UNITED STATES
DEPARTMENT OF THE INTERIOR
BUREAU OF LAND MANAGEMENTFORM APPROVED
OMB NO. 1004-0137
Expires: January 31, 2018**SUNDRY NOTICES AND REPORTS ON WELLS**
*Do not use this form for proposals to drill or to re-enter an abandoned well. Use form 3160-3 (APD) for such proposals.*5. Lease Serial No.
NMNM114356

8. Well Name and No.
SANDY FED #19. API Well No.
30-015-21126

Sec 24 T23S R30E 1980FNL 660FWL
32.293120 N Lat, 103.840782 W Lon

Well: SANDY FEDERAL-1
 API: 3001521126
 @ Srfce: T23S-R30E,24.1979n660w
 @ M TD: T23S-R30E,24.1979n660w
 Estate: FV/F

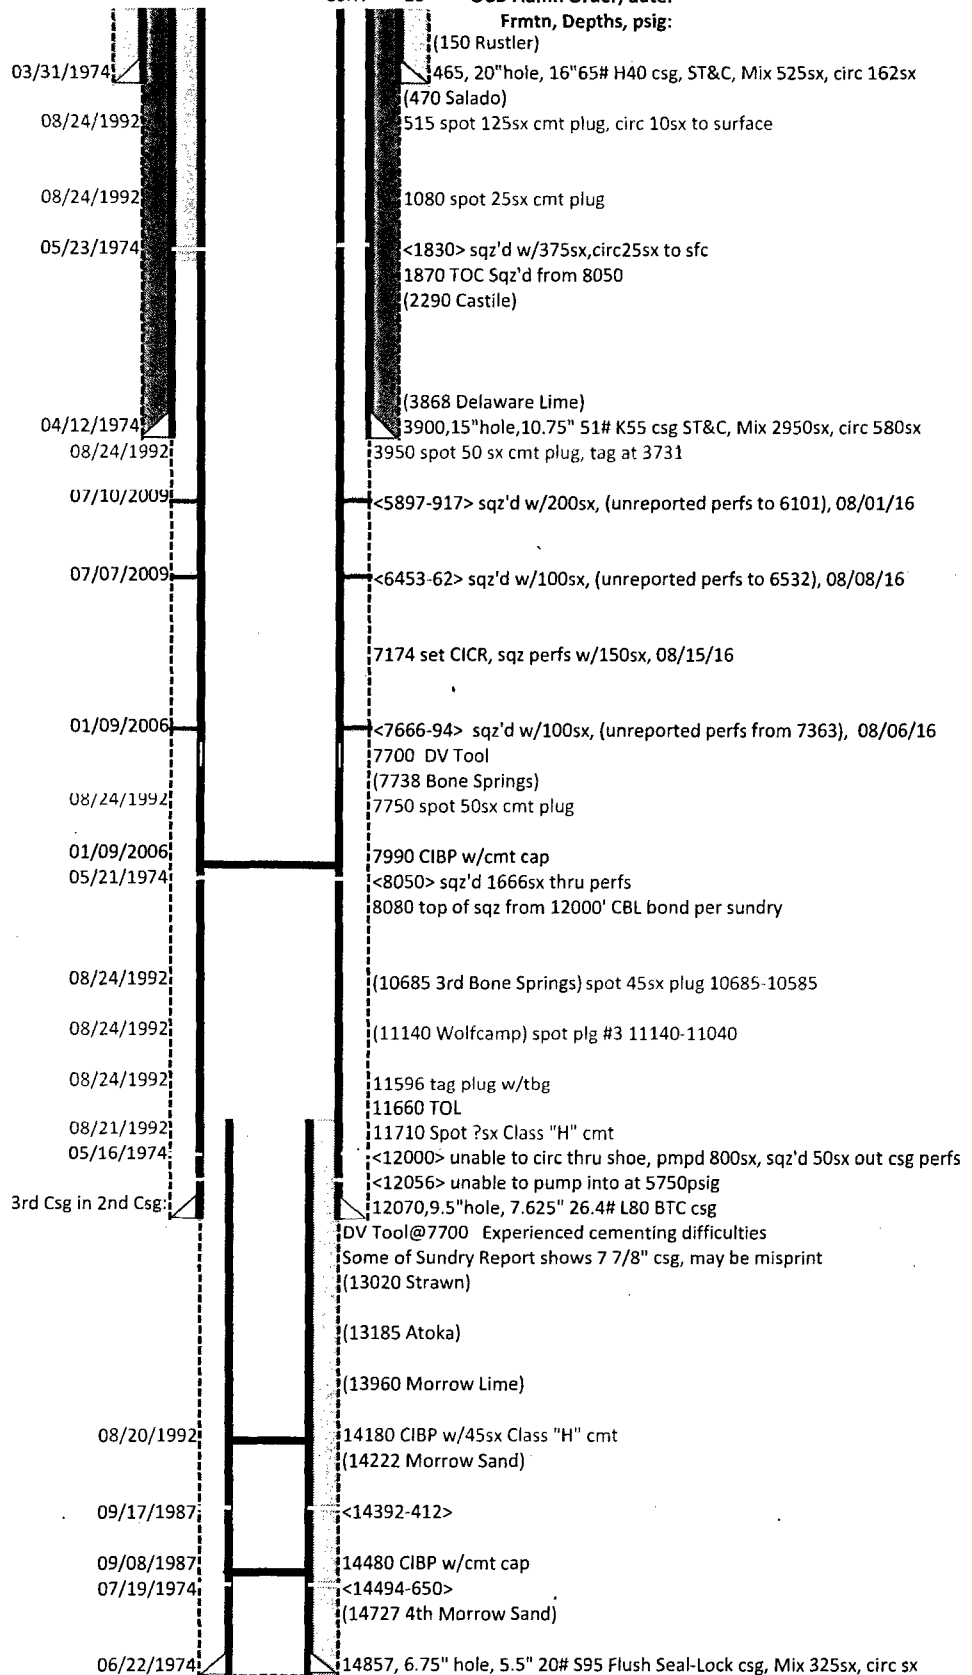
07/20/2017 The ES #376984 report lacks necessary information. Well preparation and justification does not warrant TA Status. Notice of Intent dated 06/28/16 (ES#343334) expired 12/01/16, 90days after approval. Last month of continuous production reported 11/2015. The wellbore not permanently plugged from the 14857TD to PBTD. Well is in noncompliant Shut-In Status. ~~See attached for sundry report guidance.~~
